Arkansas School for Mathematics, Sciences, and the Arts

ADDENDUM #2

DATE: 10/20/2026
SUBJECT: ASMSA FB-27-002

3 | WOMENS 102 - EAST

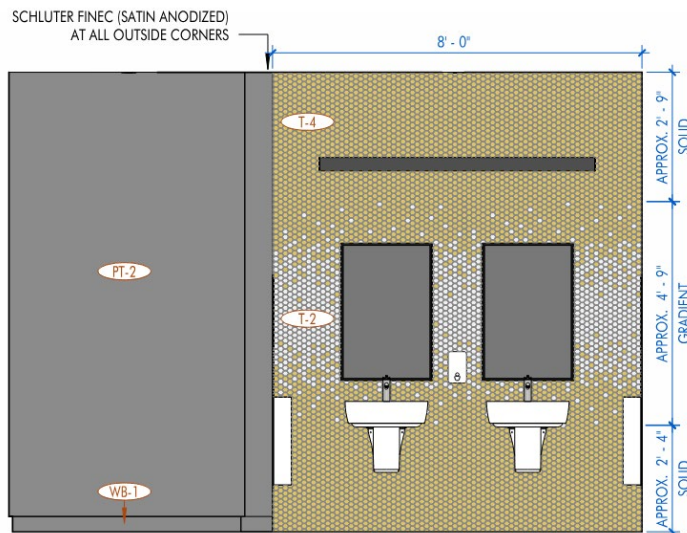
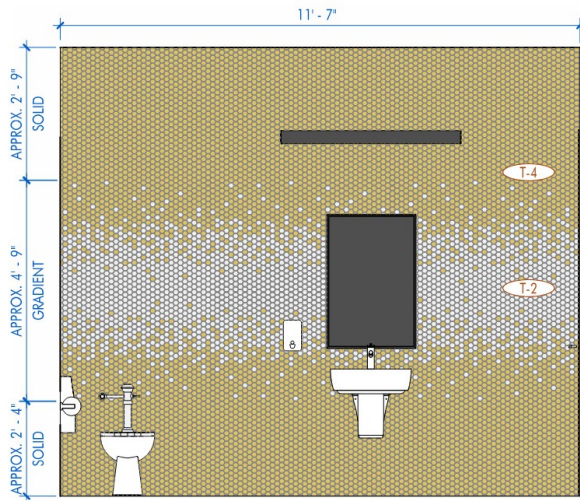
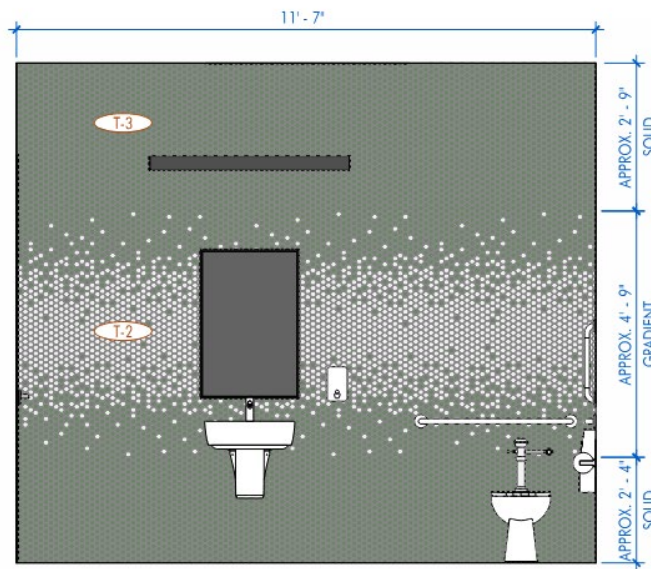
Answer: Provide tile as indicated in the elevations. These are mesh-backed tiles and are factory blended (for the Dal-Tile basis-of-design product). Contact your Dal-Tile representative for the pricing for this installation. Additional approximate dimensions are provided below.

C301

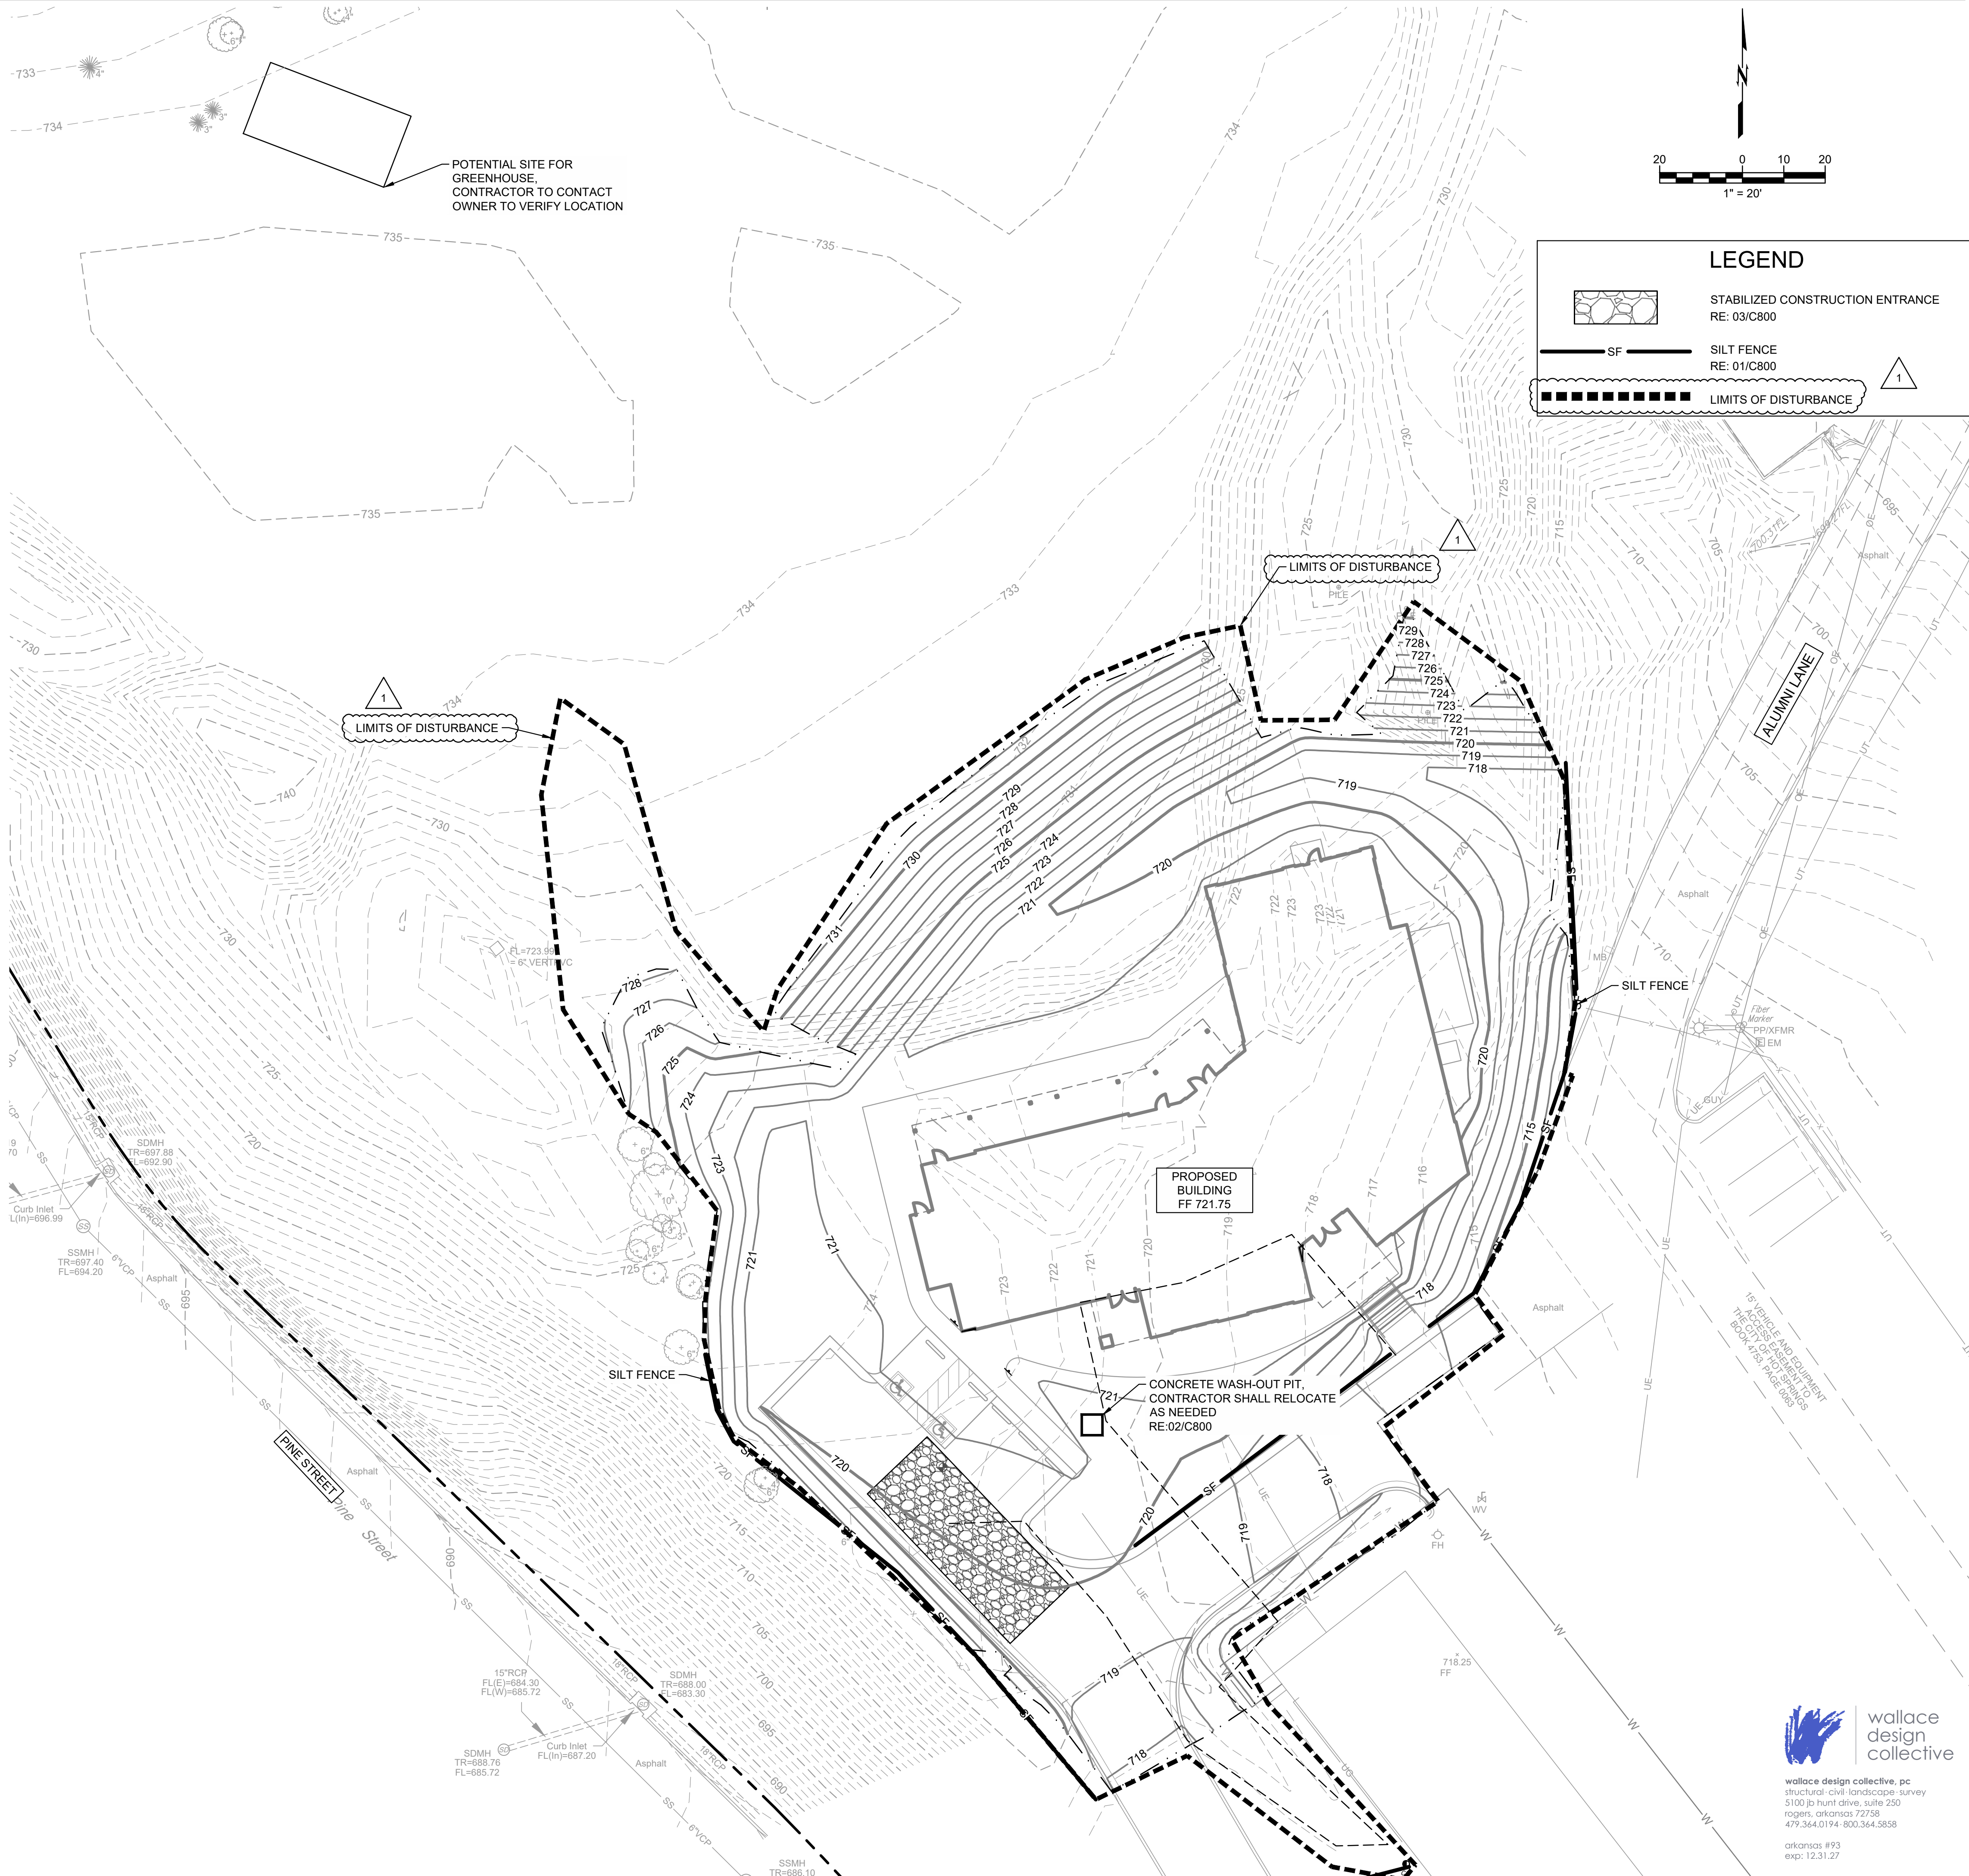
32. Confirm the limits of disturbance on the site. Seems unclear in the drawings.

1. Sheet LS.01, Drawing 1: On the north wall of the Gym, adjacent to the Fire Extinguisher Cabinet, near door 101-01, and Column Line E, add a callout that reads "AED" and point to the defibrillator indicated.
2. Sheet C301: Delete previously issued sheet. Insert revised C301 sheet attached.
3. Sheet C500: Delete previously issued sheet. Insert revised C500 sheet attached.
4. Sheet L101: Delete previously issued sheet. Insert revised L101 sheet attached.
5. Sheet A2.01, Drawing 1: On the east wall, between column lines 1 and 2, delete the callout W11 and replace it with a callout that reads W9.
6. Sheet A2.01, Drawing 1: On the SW corner of Multipurpose Room 113, between Column Lines A and B, delete the callout W7 and replace it with a callout that reads W6.

Answer: Refer to attached revised sheet C301.
